MEETING:	PLANNING AND REGULATORY COMMITTEE
DATE:	25 OCTOBER 2023
TITLE OF REPORT:	<p>190111 - OUTLINE PLANNING APPLICATION FOR THE ERECTION OF UP TO 120 DWELLINGS WITH PUBLIC OPEN SPACE, LANDSCAPING AND SUSTAINABLE DRAINAGE SYSTEM (SUDS) AND VEHICULAR ACCESS POINT FROM THE A44. ALL MATTERS RESERVED EXCEPT FOR MEANS OF ACCESS AT LAND AT FLAGGONERS GREEN, SOUTH OF THE A44, WEST OF PANNIERS LANE, EAST OF CHANCTONBURY AND NORTH OF PENCOMBE LANE, BROMYARD, HEREFORDSHIRE,</p> <p>For: Gladman Developments Ltd per Gladman Developments Ltd, Gladman House, Alexandria Way, Congleton Business Park, Congleton, Cheshire CW12 1LB</p>
WEBSITE LINK:	https://www.herefordshire.gov.uk/info/200142/planning_services/planning_application_search/details?id=190111
Reason Application submitted to Committee – Re-direction

Date Received: 11 January 2019

Figure 1 – Preferred pedestrian connectivity solution from east of site along Panniers Lane

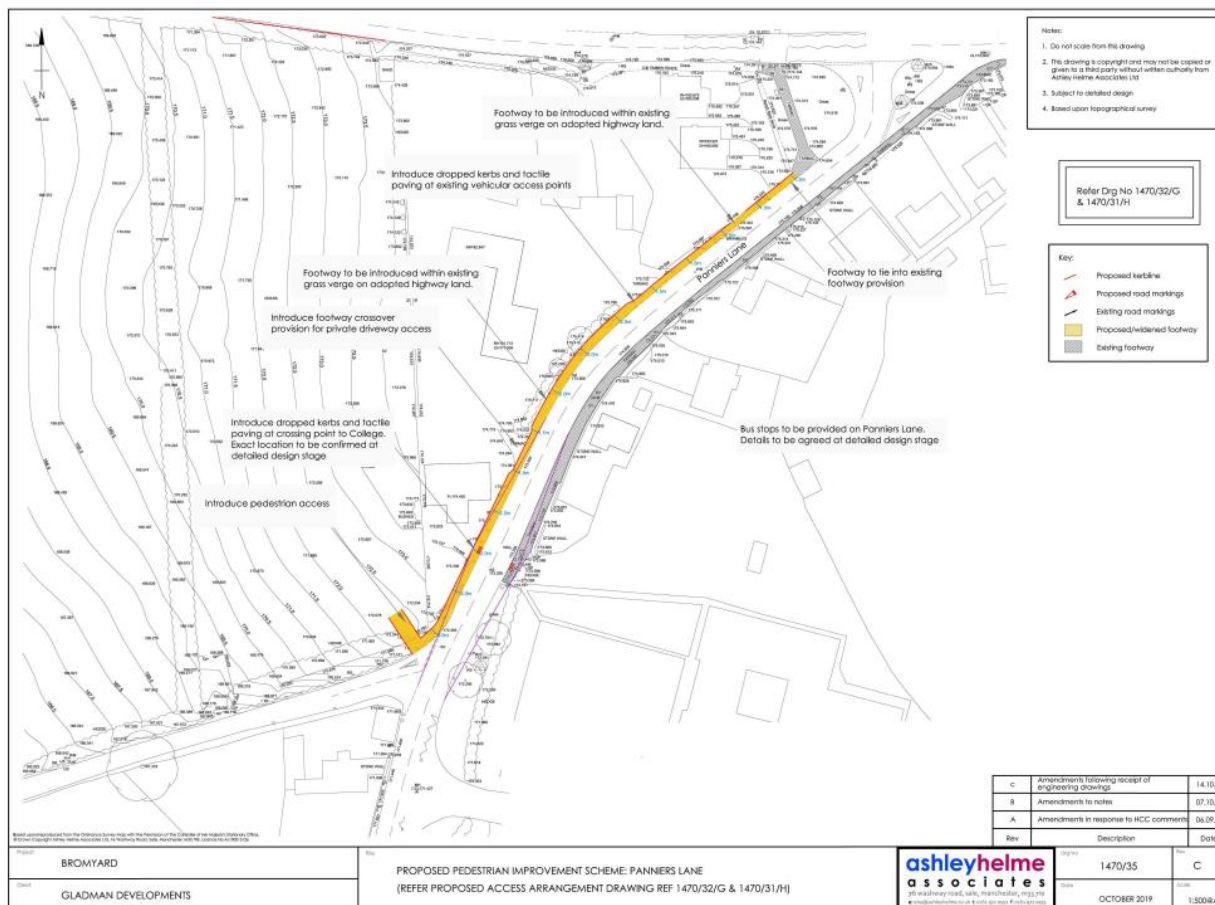
7.32 In terms of pedestrian connectivity from the site to, and along Panniers Lane a new footway is proposed along the western side of Panniers Lane. The point of connection would be taken from the southeastern corner of the site, close to the junction of Panniers Lane and Pencombe Lane. The preferred option is to provide a continuous footway along the western side of Panniers Lane (**Figure 1**), linking to the footway at its junction with the A44. Taking account of considered land ownership issues along the western side of Panniers Lane, an alternative footway scheme has been proposed which provides a footway for half the length with an uncontrolled crossing at its terminus but with a toucan crossing opposite the opposite the pedestrian access point to the Queen Elizabeth High School.

7.33 In the full length preferred footway option, the width of the footway would be 2-metres for the first 90-metres, with the remaining 50-metres being 1.5-metres in width. The footway would provide an uncontrolled crossing point roughly opposite the pedestrian access point to the Queen Elizabeth High School, with details to be secured at the detailed design stage. The LHA have not raised any objection to the width of the footway here and both schemes have been subject to a Stage 1 Road Safety Audit (RSA). A Stage 2 RSA would be required at the detailed design stage (Section 278).
